# Access Compliance Report

## Public Rights-of-Way

Intersection ID: 28212	Main Street: CHASEWATER_DR	Cross Street: DARBY_CHASE_DR	Location:	N
ADA ID: F838B1843AC1	Ramp Type: Perp	Initial Pass/Fail: Pass	Overall Compliance: No	Severity Score: 25

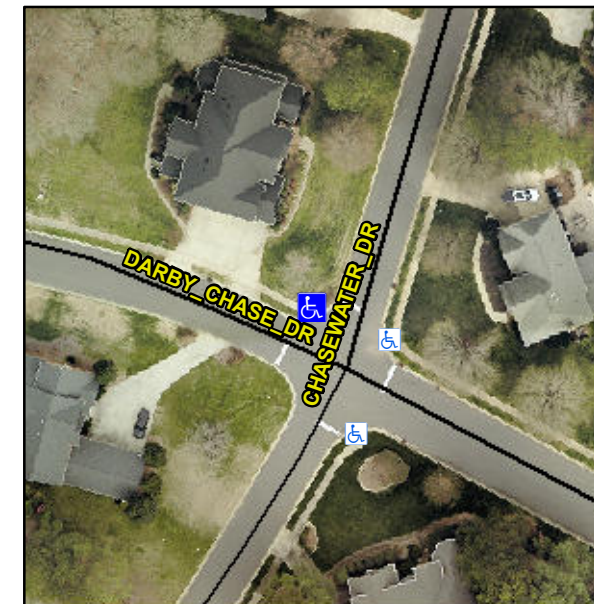
**Not Found, R304.2.1, R304.2.2-Perp, R304.3.2-Para, R304.5.3, R305.2, R302.7.2**

Compliance	Description	Data	Compliance	Description	Data
N/A	Ramp Length (in)	65.0	Yes	Ramp Slope (%)	5.5
Yes	Ramp Width (in)	48.0	Yes	Ramp XSlope (%)	1.5
N/A	Flare Type LT	Sloped	N/A	Flare Type RT	N/A
N/A	Flare Slope LT (%)	1.2	N/A	Flare Slope RT (%)	4.4
N/A	Flare Traversable LT?	Yes	N/A	Flare Traversable RT?	No
No	Landing Length (in)	N/A	Yes	DWS Provided?	Yes
No	Landing Width (in)	N/A	Yes	DWS Contrast?	Yes
No	Landing Slope (%)	N/A	Yes	DWS Length (in)	24.5
No	Landing X Slope (%)	N/A	Yes	DWS Full Width?	Yes
N/A	Landing Curb? (Y/N)	No	No	DWS Offset (in)	5.0
N/A	Shared Landing?	No			
Yes	Gutter Ponding?	No	Yes	Gutter Slope (%)	2.8
No	Gutter Lip Ht (in)	1.5	Yes	Gutter X Slope (%)	0.1
N/A	Painted X Walk1?	No	N/A	Painted X Walk2?	N/A
	X Walk 1 Direction	To SE		X Walk 2 Direction	N/A
N/A	X Walk 1 Width (in)	N/A	N/A	X Walk 2 Width (in)	N/A
	X Walk 1 Slope (%)	2.4		X Walk 2 Slope (%)	N/A
	X Walk 1 X Slope (%)	2.3		X Walk 2 X Slope (%)	N/A

**Remove & Replace Entire Ramp.**
